# Product Change Notification

Product Change Notification: P-20-020024

RECEPTACLE CONTACT FOR 5mm PITCH CONNECTOR. (STRIP FORM)

PCN  
Packaging Change  
for  
PN 282308-1  
PN 282310-1

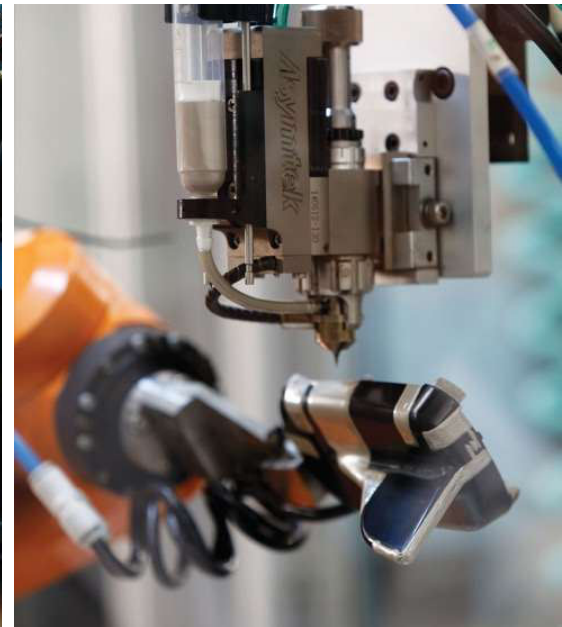
Product improvement. Packaging changes: 1) Carton box dimensions from 270x270x485 mm to 270x270x480 mm. 2.1) Reel outer diameter from 270 mm to 269 mm. 2.2) Reel inside width from 143 mm to 150 mm. 2.3) Reel core diameter from 82 mm to 85 mm. 2.4) Reel diameter hole for pin from 21.1 mm to 22 mm. 3) Interleaving paper width from 145 mm to 153 mm.

Current used packaging	New packaging
<p>336830-1 Carton 270x270x485 mm</p> 	<p>725638-8 Carton 270x270x480 mm</p>
<p>142002-1</p> <ul style="list-style-type: none"> <li>- ReelØ270 mm</li> <li>- inside width 143 mm</li> <li>- CoreØ 82 mm</li> <li>- Ø hole for pin: 21,1 mm</li> </ul> 	<p>1-725652-0</p> <ul style="list-style-type: none"> <li>- ReelØ269 mm</li> <li>- inside width 150 mm</li> <li>- CoreØ 85 mm</li> <li>- Ø hole for pin: 22,0 mm</li> </ul> 
<p>Paper 3-973177-3 (W=145 mm, 90gr)</p>	<p>Paper 3-973177-6 (W=153 mm, 90 gr).</p>
